# PLANNING APPROVAL & PLANNED UNIT DEVELOPMENT

STAFF REPORT Date: August 17, 2006

**NAME** Port City Church of Christ

**LOCATION** 2901 Hillcrest Road

## SITE PLAN

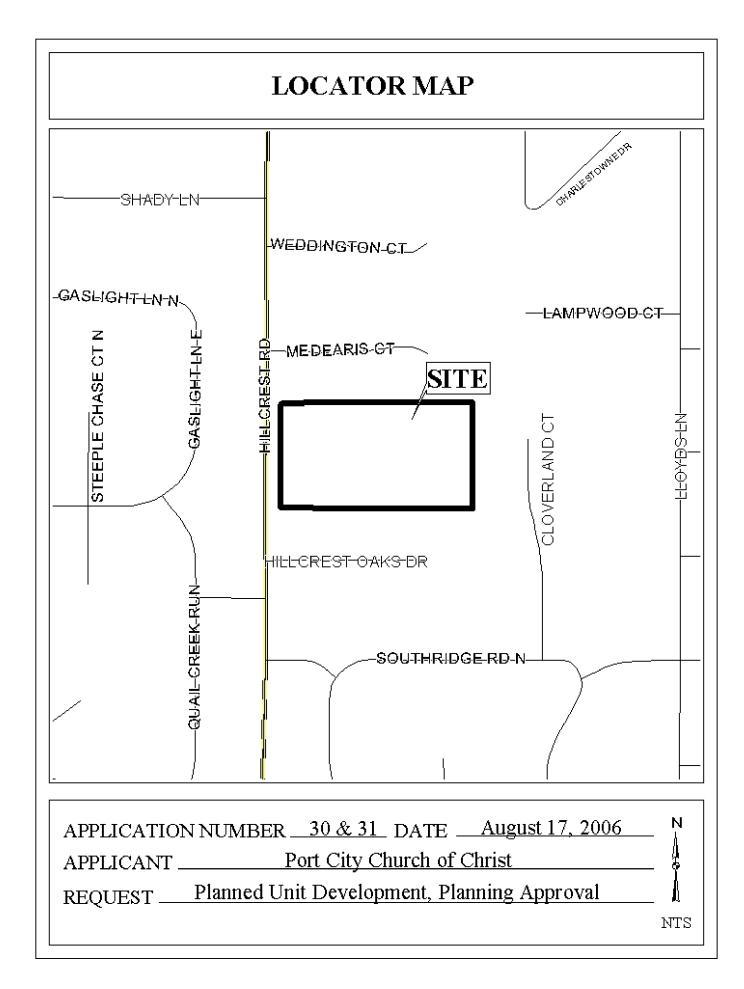
The site plan depicts the proposed 40 by 50 foot addition to the front of one of the existing buildings. The two existing buildings on the site total 12,890 square feet. The applicant has not provided any information regarding the proposed use of the addition, however, the addition will comply with all building setback requirements. The proposed 2,000 square foot addition is not anticipated to create incompatibilities for the neighboring residential uses. It will be required, however, that any new construction, whether to expand existing buildings or provide new buildings, be subject to a new PUD and Planning Approval review, as any approval resulting from the current application is site plan specific.

While the building addition should be generally compatible with the overall area, the applicant should ensure that a 6-foot high privacy fence, located on the Church's property, is provided along the South, East and North perimeters of the site, except where within 25-feet of Hillcrest Road, where the fence may only be 3-feet in height. While adjacent residences may have existing fences, it is the obligation of the applicant to additionally provide a fence to ensure proper buffering; this requirement may result in double fences at property lines.

The site plan approved in May 2005 is different that the site plan that has been provided with this application. Specifically, the parking lot layout is different than approved, and the quantity of parking spaces is also different. The current site plan is labeled as providing 177 spaces, although a count of the spaces indicates that there are only 172 depicted. The site plan from May 2005 was labeled as providing 167 parking spaces, although 195 were depicted on the site plan. Inspection of the site by Urban Development staff also identified several other discrepancies with the submitted site plan, specifically, the site contains two detention areas, a dumpster storage facility, a seating area with benches, and a drop-off area in the parking lot rather than parking spaces, none of which are depicted on the site plan. Therefore, prior to the issuance of a Certificate of Occupancy for the building addition, a revised site plan showing the as-built condition of the parking area, the existing structures, the existing detention, the existing dumpster location, any other site improvements, and the proposed 2,000 square foot addition, must be provided to Urban Development, Planning Section.

The site fronts Hillcrest Road, a major street, which has an existing right-of-way width of 100 feet, and therefore complies with the Major Street Plan. Because Hillcrest is a major street, access management is a concern. The site should be limited to the existing curb-cuts, and the existing median should remain intact in order to reduce turning movements to/from southbound Hillcrest Road.

**RECOMMENDATION** Planning Approval: based on the preceding, it is recommended that the proposed 2,000 square foot building expansion be approved as depicted on the submitted site plan, subject to the following conditions: 1) placement of a note on the site

Planned Unit Development: based on the preceding, it is recommended that the proposed 2,000 square foot building expansion be approved as depicted on the submitted site plan, subject to the following conditions: 1) placement of a note on the site plan stating that Planning Approval and PUD approval are site plan specific, and that modifications to the site or building additions will require new Planning Approval and PUD applications; provision of 2) landscaping and tree planting in accordance with the quantities and ratios set forth in Section IV.E.3. (Minimum Landscape Requirements) of the Zoning Ordinance, as amended, and comply with Sections 64-4.E. of the Ordinance; 3) full compliance with Section 64-6. (Off-Street Parking Requirements) of the Zoning Ordinance, as amended; 4) placement of a note on the site plan stating that the lot is limited to the existing curb-cuts, with no breach of the existing median on Hillcrest Road; 5) full compliance with Engineering comments: (If existing detention is to be used to accommodate the proposed building, a survey must be provided to confirm the volume and functionality of the existing drainage system. Must comply with all stormwater and flood control ordinances. Any work performed in the right of way will require a right of way permit. The applicant is responsible for verifying if the site contains wetlands. The site can be checked against the National Wetlands Inventory on the COM web site Environmental Viewer. If the site is included on the NWI, it is the applicant's responsibility to confirm or deny the existence of regulatory wetlands.) 6) placement of a note on the final site plan stating that "preservation status is to be given to the 48" Live Oak Tree located on the South side of Lot and the 50" Live Oak Tree located in the South East corner of Lot. Any work on or under these trees is to be permitted and coordinated with Urban Forestry; removal to be permitted only in the case of disease or impending danger."; 7) provision of a 6-foot high privacy fence on the property in question, around the South, East and North property boundaries, except within 25-feet of Hillcrest Road, where the fence shall be no more than 3-feet in height; 8) provision of a revised site plan to Urban Development, Planning Section, accurately depicting the "as-built" condition of any stormwater detention facilities, dumpster facilities, existing buildings, the parking area, any other existing or required site improvements, and the proposed 2,000 square foot addition that is the subject of this application, prior to the issuance of a Certificate of Occupancy; 9) submittal of a Subdivision application for Planning Commission consideration in conjunction with any future applications to the Planning Commission; and 10) full compliance with all other applicable municipal codes and ordinances.
